Amendments to the Drawings:

Title: SEMICONDUCTOR WAFER TREATMENT MEMBER Inventor(s): Masanari YOKOGAWA et al. Appl. No.: 10/603,781

Fig.4

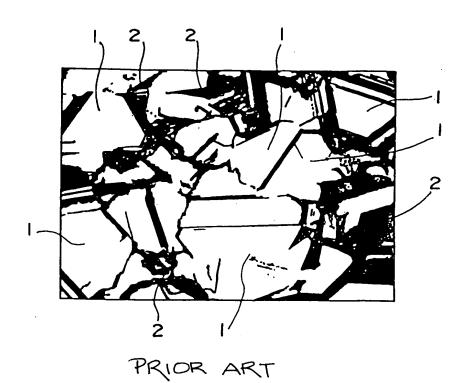
The specific changes which have been made to Figures 4-6 comprise the addition of a legend to indicate that those Figures are prior art.

The PTO has stated that Figures 3-6 should be designated as Prior Art. Although Figures 4-6 have been amended to include such a legend, the Applicant believes that Figure 3 may have been included in the objection as an oversight. Figure 3 does not show prior art but rather an aspect of the present invention; see page 8, lines 4-6 of the specification. Applicant requests reconsideration with regard to Figure 3.
